CITY PLAN COMMISSION**THURSDAY, JUNE 1, 2023****FILE NUMBER:** S223-148**CHIEF PLANNER:** Mohammad H. Bordbar**LOCATION:** Briarbank Circe, at the terminus of Abraham Drive**DATE FILED:** May 8, 2023**ZONING:** TH-2(A)**CITY COUNCIL DISTRICT:** 7 **SIZE OF REQUEST:** 0.209-acres**MAPSCO:** 49-Y**APPLICANT/OWNER:** Southern Homes Ventures, LLC

REQUEST: An application to create one 0.209-acre (9,105.84-square foot) lot from a tract of land in City Block 6769 on property located on Briarbank Circe, at the terminus of Abraham Drive.

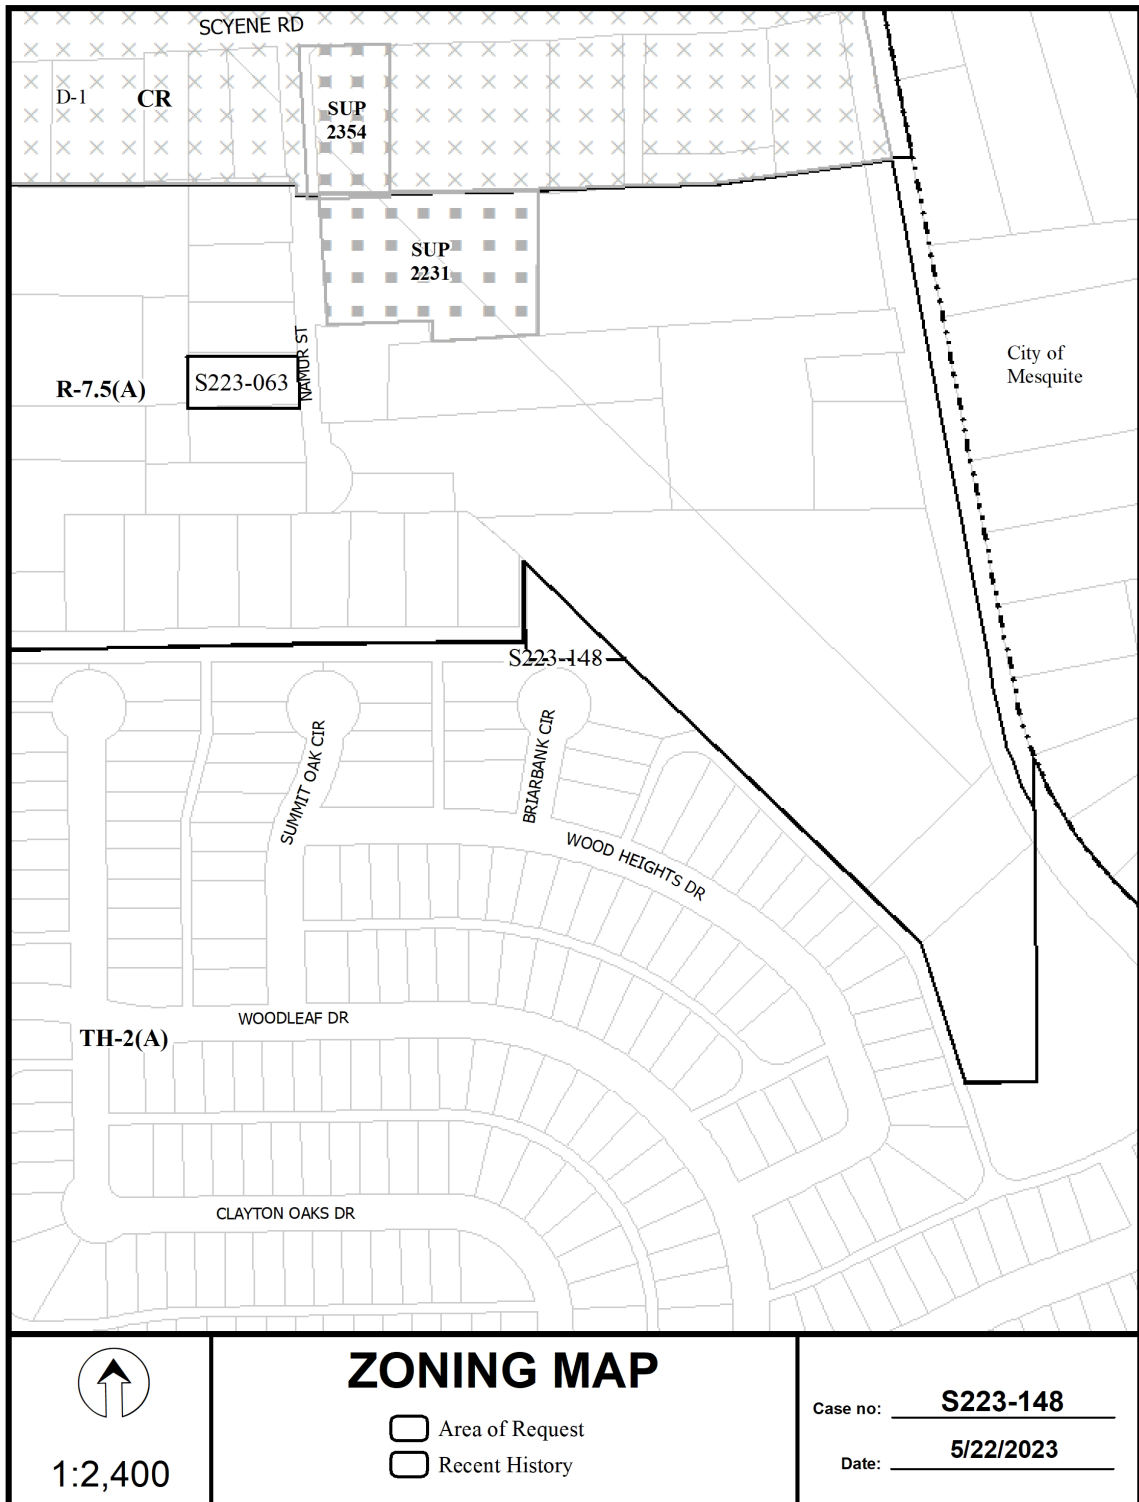
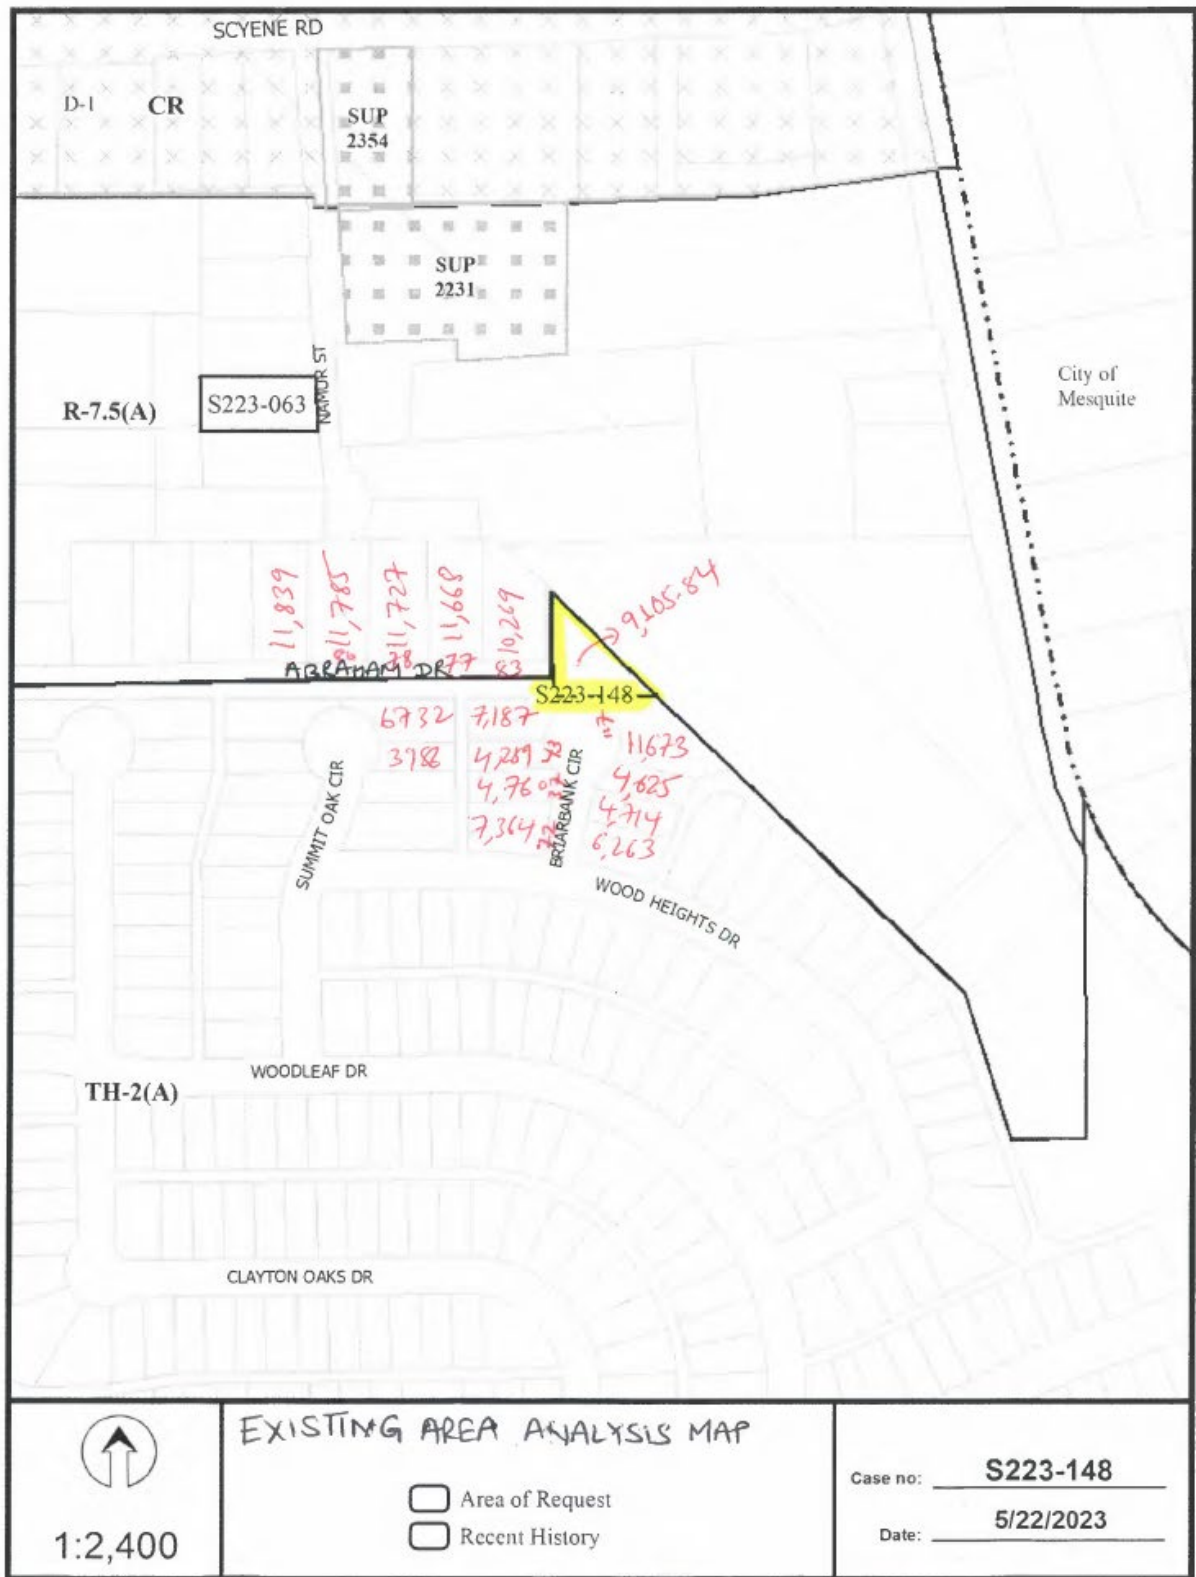
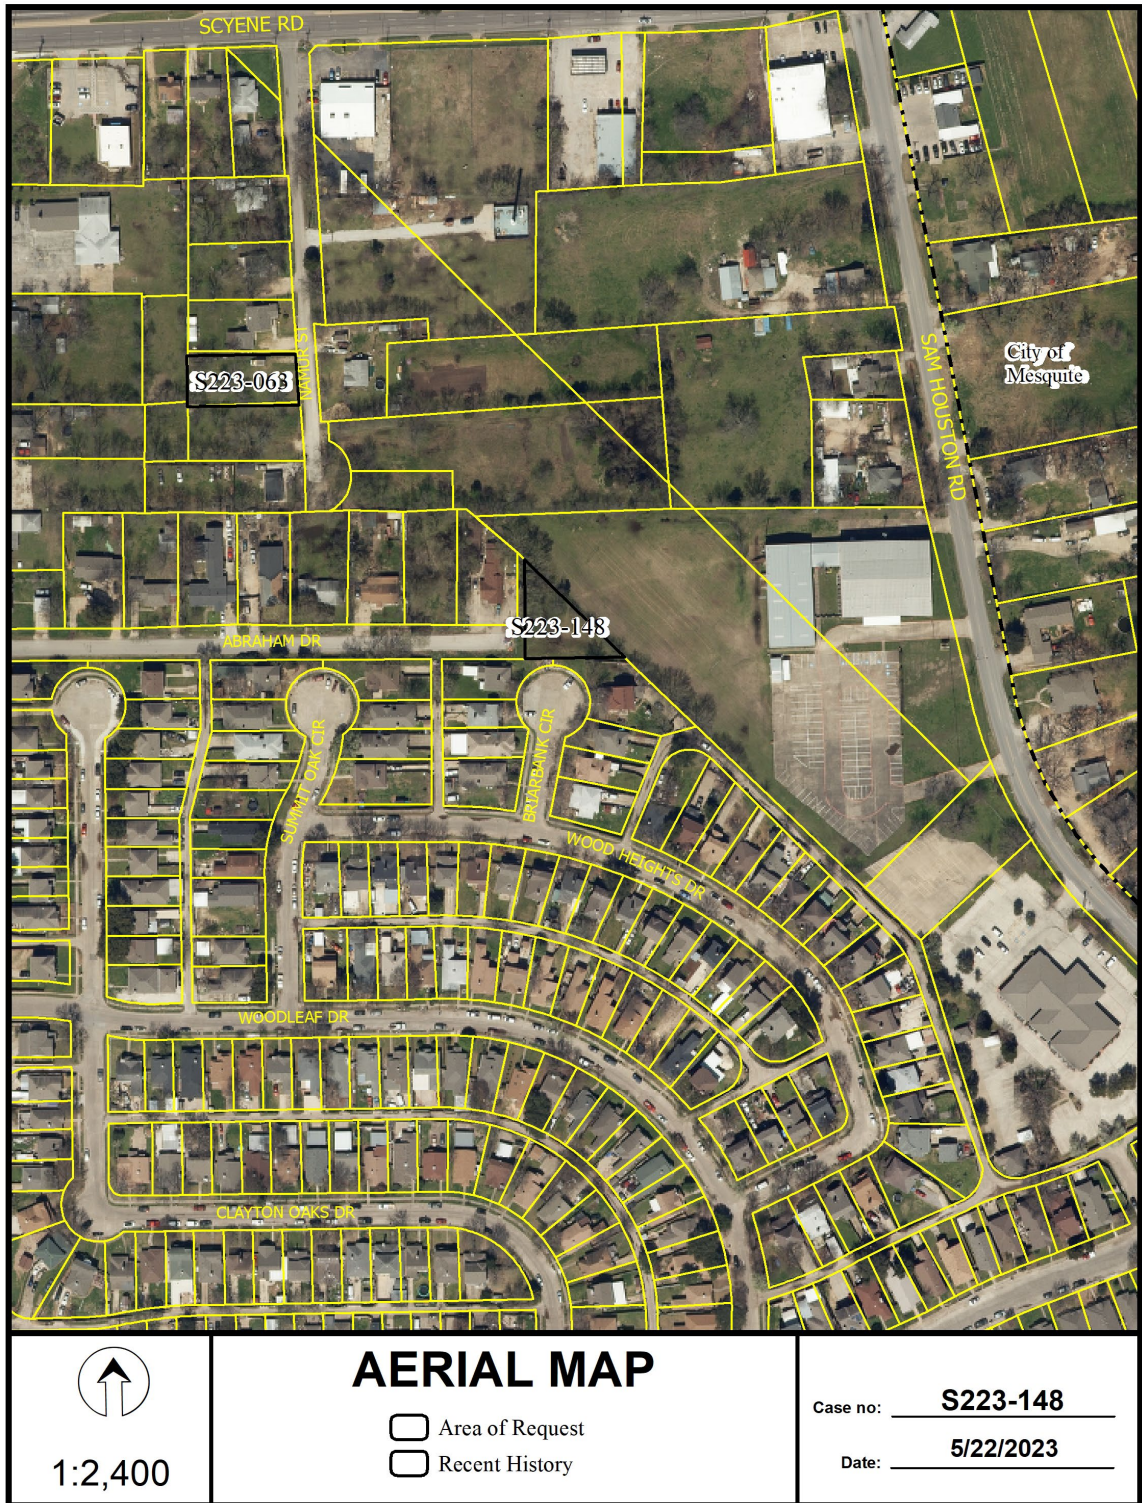
- The properties to the south of the request have lot widths ranging in size from 37 feet to 107 feet and lot areas ranging in size from 3,986 square feet to 11,673 square feet and are zoned TH-2(A) Townhome District. *(refer to existing area analysis map)*
- The properties to the west of the request have lot widths ranging in size from 77 feet to 83 feet and lot areas ranging in size from 10,269 square feet to 11,839 square feet and are zoned an R-7.5(A) Single Family District. *(refer to existing area analysis map)*

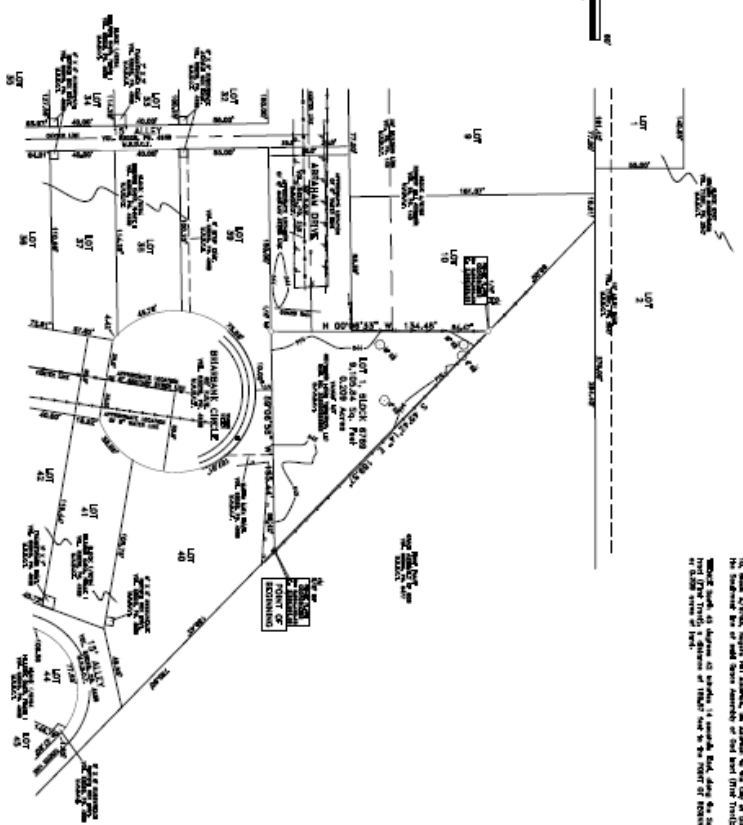
19. Additional design information is required for assessment. Site plan must be submitted showing proposed development, building finished floor elevation, development, existing mains – including downstream manhole, and proposed water and wastewater service locations. Submit water/wastewater engineering plans to 320 E. Jefferson Blvd., Room 200, Attention: Water and Wastewater Engineering.
20. Water and wastewater main improvements are required by Private Development Contract. Submit water/wastewater Engineering Plans to 320 E. Jefferson Blvd., Room 200, Attention: Water and Wastewater Engineering.
